PREVOST

WARRANTY BULLETIN

WB23-33

DATE :	February 2024	SECTION :	18 BODY
EXPIRATION:	February 2026		
SUBJECT :	INSTALLATION 100th ANNIVERSARY LOGO

REAR ENGINE DOOR LOGO INSTALLATION

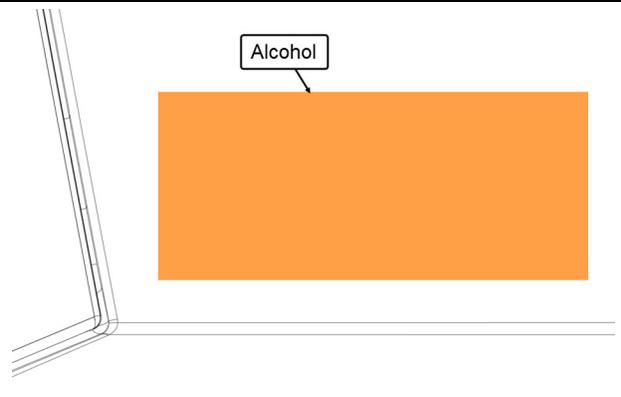
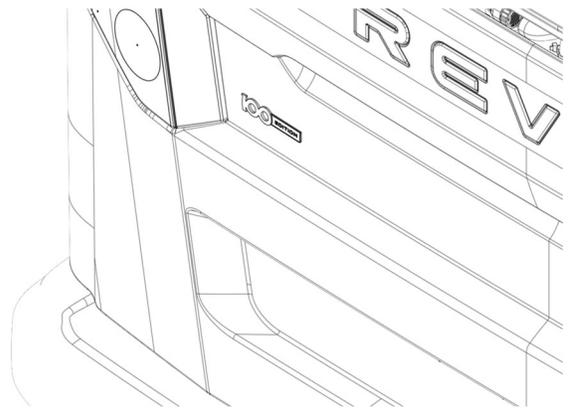
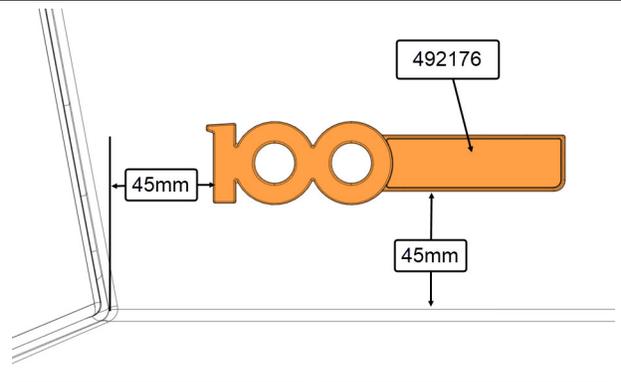
1. Locate the middle left of the rear engine door.

2. Clean the surface with alcohol.

3. Install the new logo 492176 in the indicated position.

RIGHT FRONT FENDER LOGO INSTALLATION

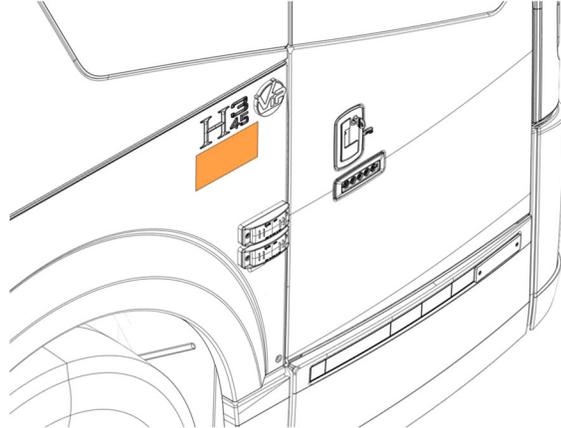
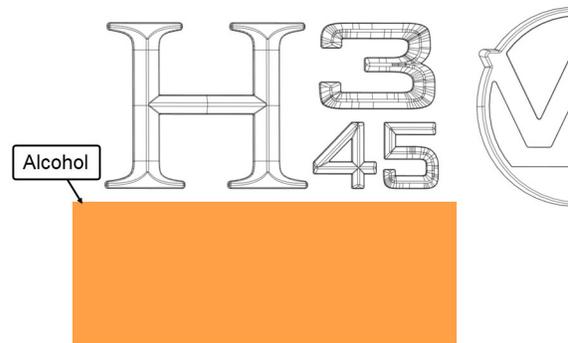
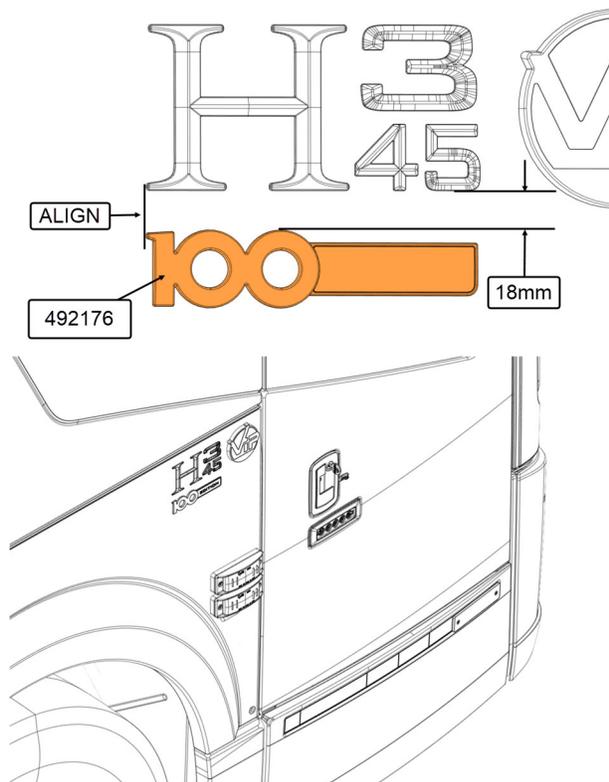
1. Locate top right of the right fender.

2. Clean the surface with alcohol.

3. Install the new logo 492176 in the indicated position under the logo H3-45.
